W3F1-2014-0073

January 21, 2015

Subject: Waterford Steam Electric Station, Unit 3 Response to Request for Additional Information Regarding a Change to the Updated Final Safety Analysis Report Clarifying Pressurizer Heaters Function for Natural Circulation (TAC No. MF3058)  
Waterford Steam Electric Station, Unit 3 (Waterford 3)  
Docket No. 50-382  
License No. NPF-38

## 25.0 Restore Pressurizer Heater Control

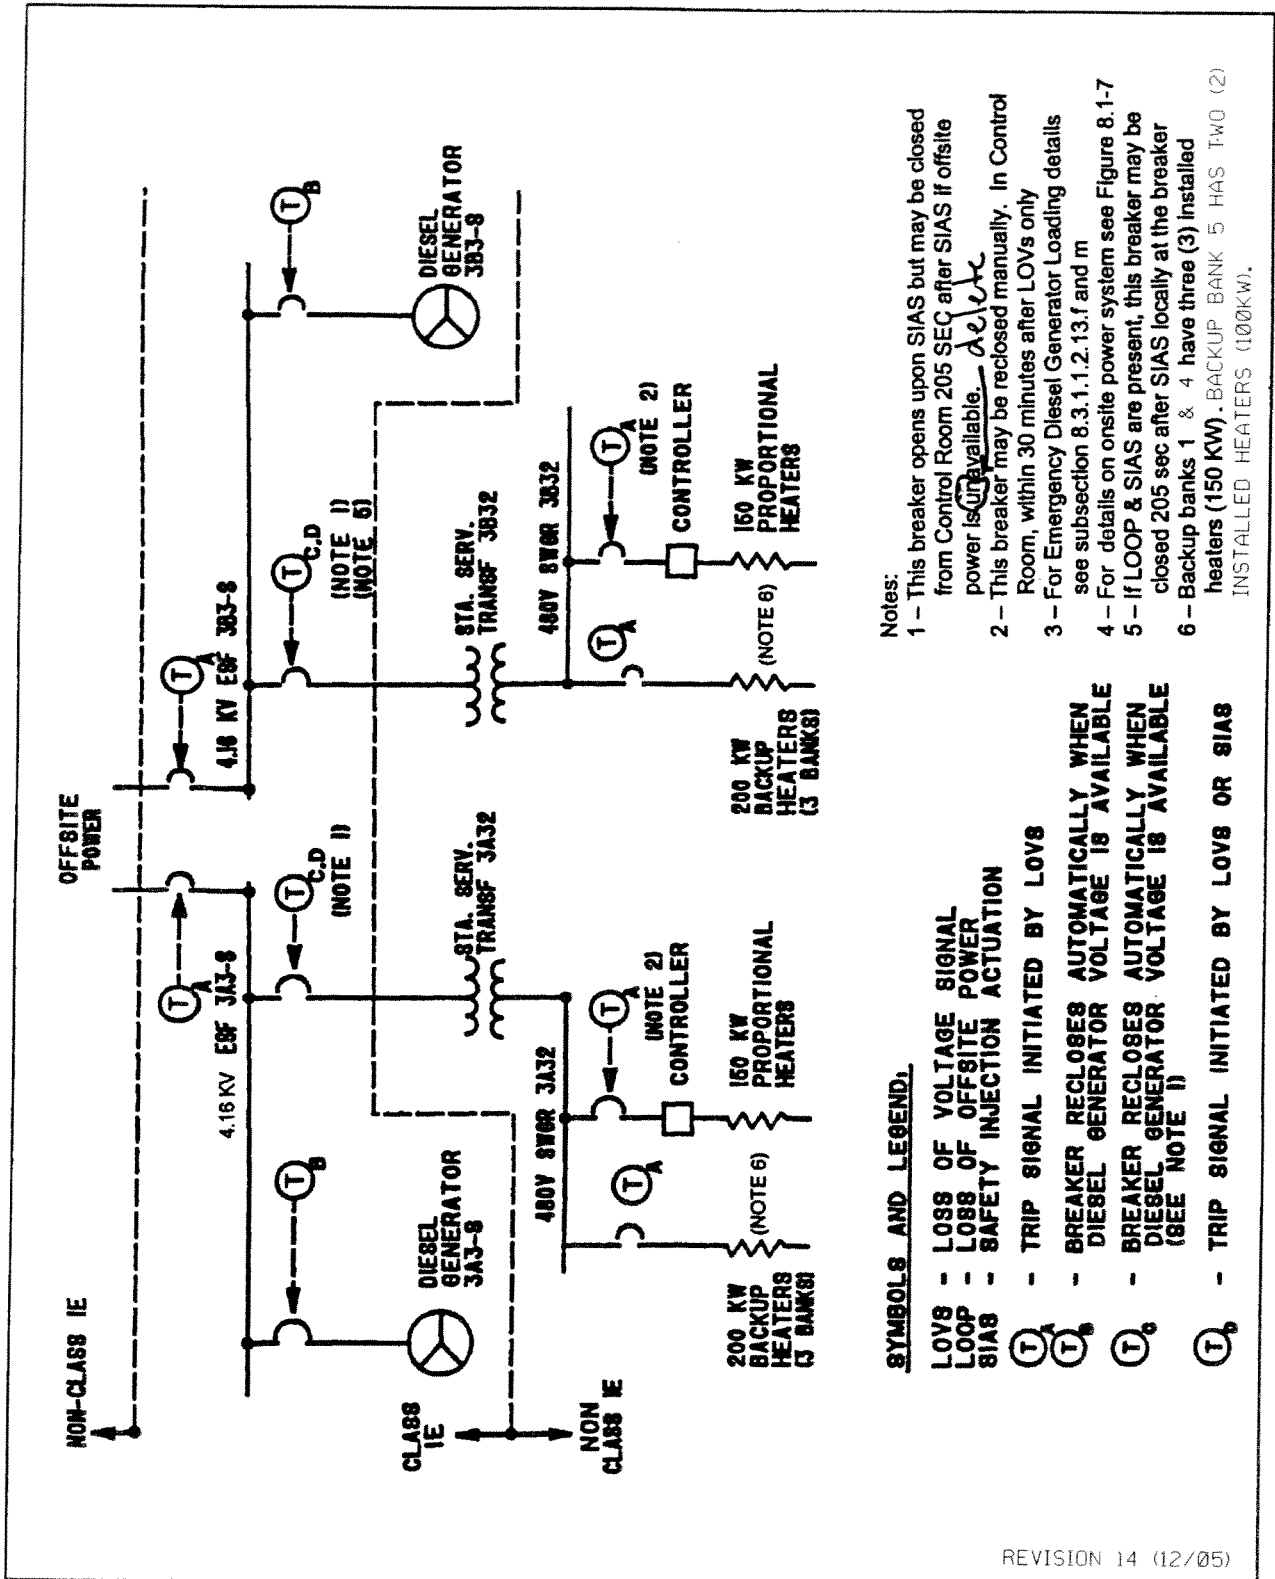
The Security SUPS, SUPS 014AB, breaker CVC-EBKR-014AB-13 provides power for the automatic loading capability of the 3A32 and 3B32 buses. With breaker CVC-EBKR-014AB-13 open the feeder breakers below would require local closure. Refer to Annunciator L0804.

4. Close SWITCHGEAR 32A SUPPLY breaker (SSD EBKR3A8).
5. Close SWITCHGEAR 32B SUPPLY breaker (SSD EBKR3B9).
6. Place PROPORTIONAL HEATER BANKS Control switches to "ON."
7. Momentarily place each BACKUP HEATER BANKS Control switches to "OFF" and THEN to "AUTO."
